**CORRECTIVE / INTERIM REMEDIAL ACTION PLAN
FOR
STID 553 -
FORMER GRIMIT AUTO AND REPAIR
1970 SEMINARY AVENUE
OAKLAND, CALIFORNIA**

**RE: CORRECTIVE / INTERIM REMEDIAL ACTION PLAN
STID 553 - FORMER GRIMIT AUTO AND REPAIR
1970 SEMINARY AVENUE
OAKLAND, CALIFORNIA**

TRANSMITTAL

DESCRIPTION 2/15/97 CAP / Interior RAP

SITE PLAN / PROPOSED REMEDIATION

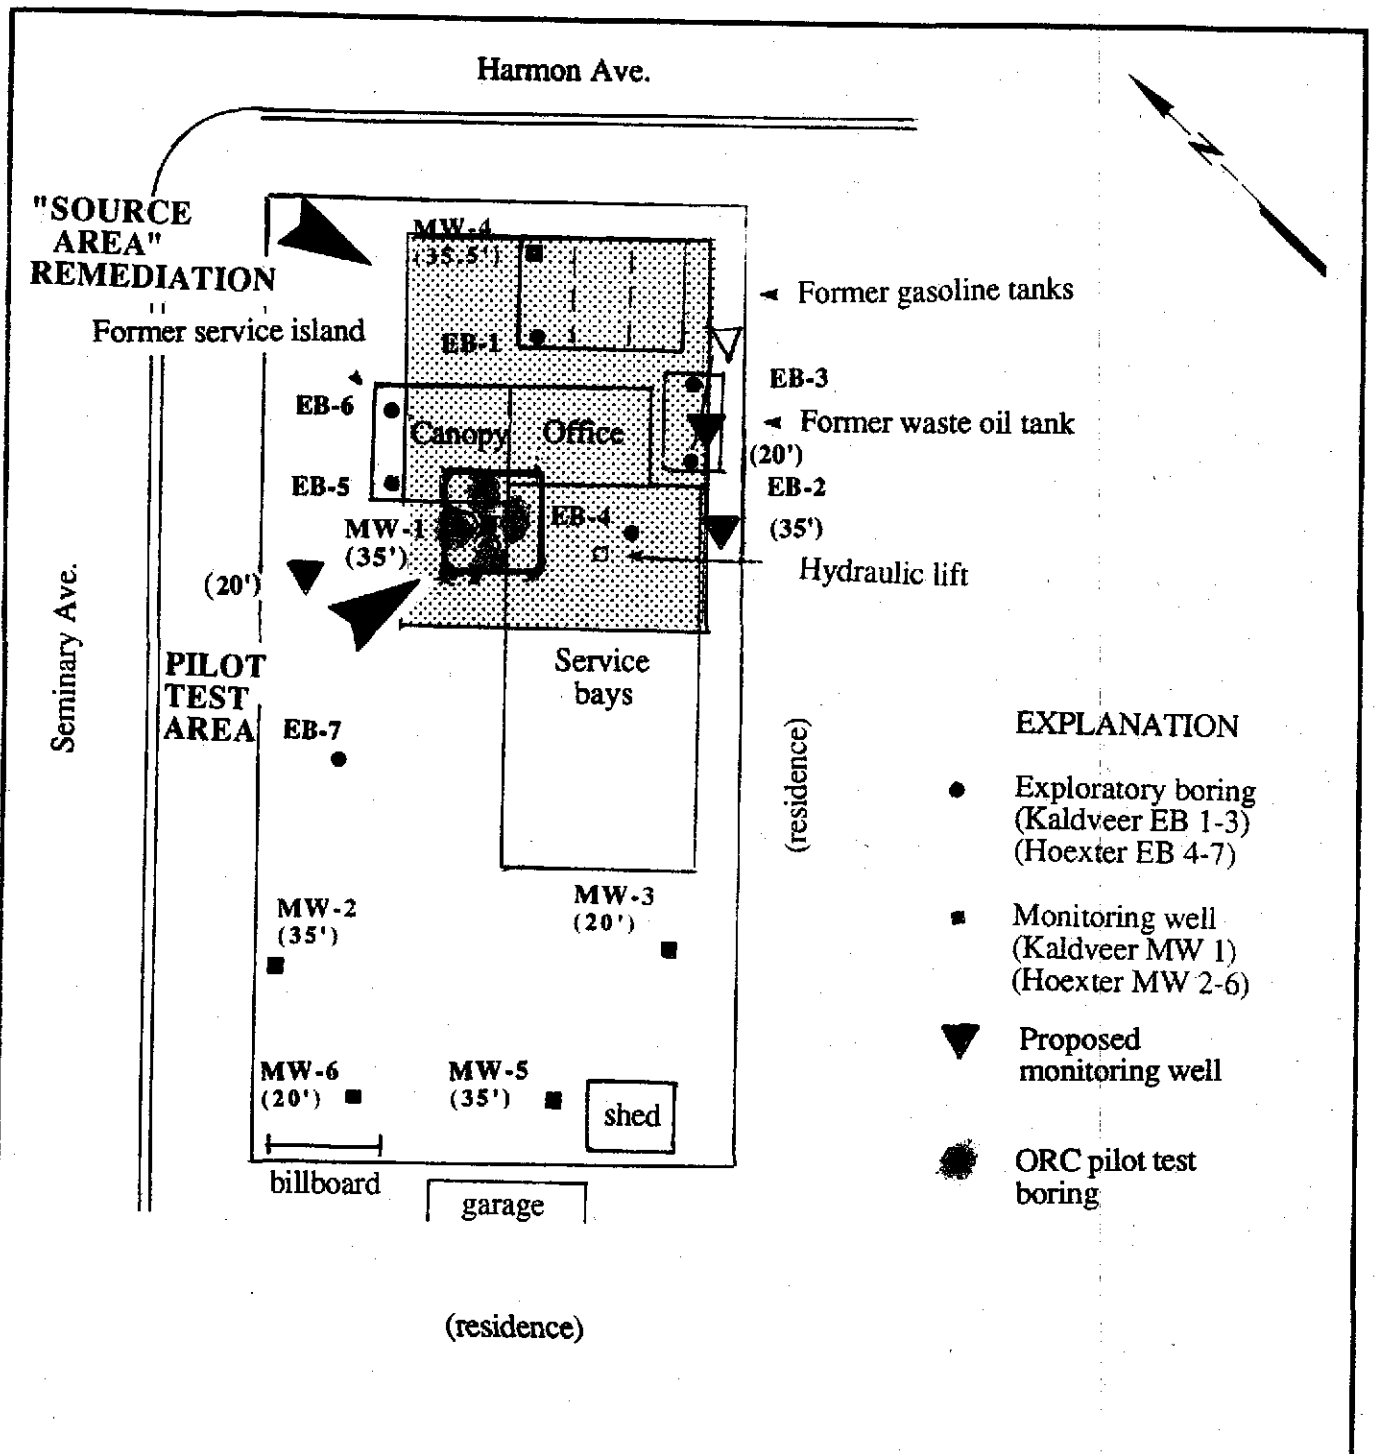
Site plan shows building / house at adjacent properties

where are residential building

The results of the calibration test will be used to complete a final design of the ORC remediation system. The current plan is to install a grid of six to nine additional borings approximately spaced at 8 to 10 foot centers within the "source area" (Figure 2). Additional, more widely spread borings, would be placed within the balance of the site, where contamination levels are less elevated. The final plan may slightly increase the number of borings and decrease the spacing. The ORC slurry would be placed in the same manner as described in Section 7.2.1, or pressure grouted, whichever is less costly. *? where?*
